Re: 5th Street Lofts Model / Sales Office, 1719 5th Street NW, Traffic Circulation Layout
Architect's Stamp dated 3-08-05 (H14-D100)

RE: 5th St. Lofts Model Unit and Sales Office
1719 5th St. NW, TCL Submission

**Re: 5th Street Lofts Model / Sales Office, 1719 5th Street NW, Traffic
Circulation Layout
Architect's Stamp dated 3-29-05 (H14-D100)**

1 SITE PLAN
1/4" = 1'-0"

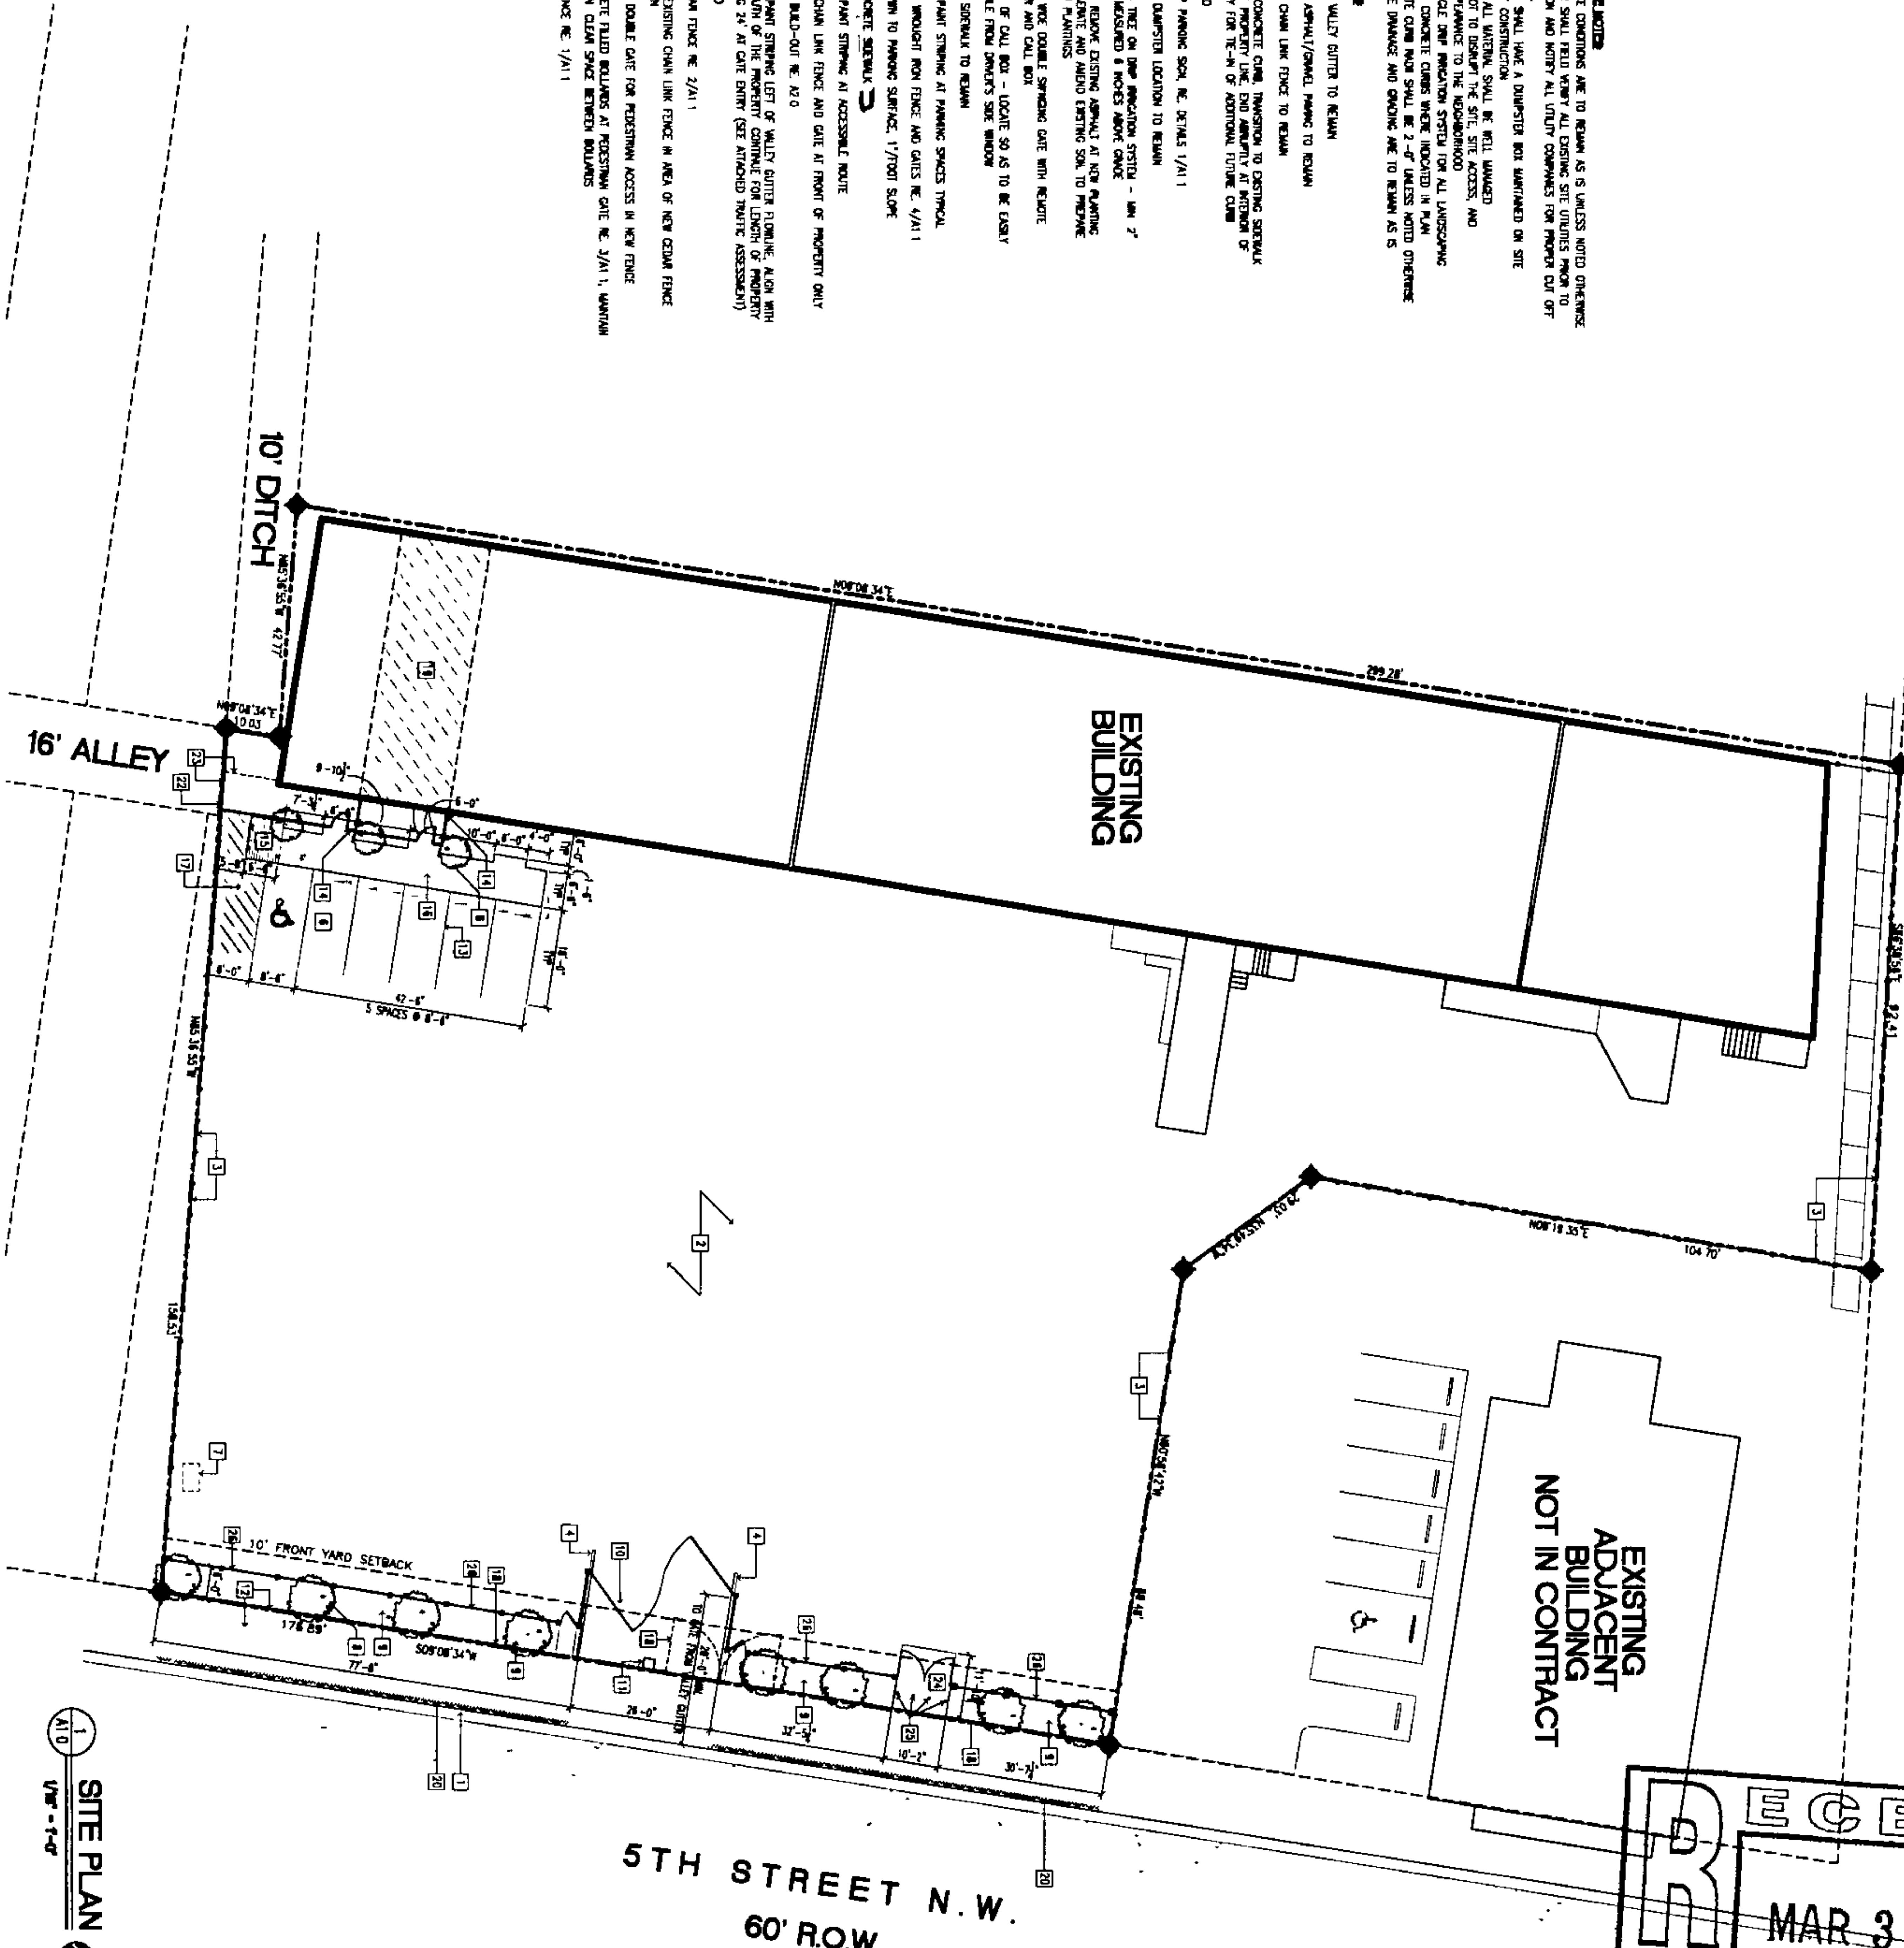
1. *Verify that the swing of the gate is contained within the private lot and does not intrude on the public Right-of-Way.*

2. *Please note that the 2-foot overhang is not allowed to encroach on the 6 foot required width of sidewalk. Also, all standard parking spaces have a minimum length of 18 feet. Therefore, the sidewalk can be 8 feet wide with a 2-foot overhang, or the parking spaces must be 20 feet in length with bumpers.*

3. *Is there an existing sidewalk along 5th Street?*

4. *Widen the gate area to provide a turn around area for passenger vehicles.*

5. *Before placing painted striping along 5th Street, you must get approval from Traffic Operations.*

1. Verify that the swing of the gate is contained within the private lot and does not intrude on the public Right-of-Way.
2. Please note that the 2-foot overhang is not allowed to encroach on the 6 foot required width of sidewalk. Also, all standard parking spaces have a minimum length of 18 feet. Therefore, the sidewalk can be 8 feet wide with a 2-foot overhang, or the parking spaces must be 20 feet in length with bumpers.
3. Is there an existing sidewalk along 5th Street?
4. Widen the gate area to provide a turn around area for passenger vehicles.
5. Before placing painted striping along 5th Street, you must get approval from Traffic Operations.

The edge of the gate at its open position is 2'-8" away from the property line. When closed, the gate is 16'-0" behind the property line. At no point in its travel path does it come closer than 2'-8" to the property line/Right-of-Way boundary.

Per Section 14-16-3-1 of the Comprehensive Zoning Code, "clear width may be reduced to 4 feet 6 inches at tree wells for a maximum distance of 10 feet. Pedestrian walkways shall also be lined with adjacent shade trees spaced approximately 25 feet on center and placed within defined planting areas that have a minimum interior dimension of 36 square feet and a minimum width of four feet." The sidewalk we designed meets the above description, and ~~are~~^{is} only reduced from six feet clear to 4'-6" clear at the tree wells.

Yes. The existing sidewalk is 12'-9" deep. There is no curb, however, and the sidewalk terminates at a valley gutter. One of the reasons that Nevin Harwick recommended striping in his queuing analysis

Eric Haskins of our firm spoke with Kristal Metro of your office regarding this issue on the morning of March 24, 2005. Kristal expressed the opinion that a vehicle needing to turn around would be able to back up into the 12'-9" wide sidewalk space and then re-enter traffic in a forward direction. We designed the gate entry based upon this recommendation. If other measures will be required, please advise.

REVISION: per Eric Haskins' conversation with you on 4-7-05, you advised measuring the thickness of the existing sidewalk in the drivepad area to determine its acceptability in the access area. The thickness was field measured to be between 2 and 4 inches, substantially less than the 6" required. We have revised our TCL submittal drawing to show replacement of the drivepad in the entry area with a new drivepad per City of Albuquerque Standard Specifications for Public Works Update 7, Drawing 2425. This detail extends into the required vehicular backup area (see TCL submittal drawing A1.0).

REVISION: A note has been added to the drawing specifying that the contractor shall obtain approval from Traffic Operations prior to painting striping along 5th Street.
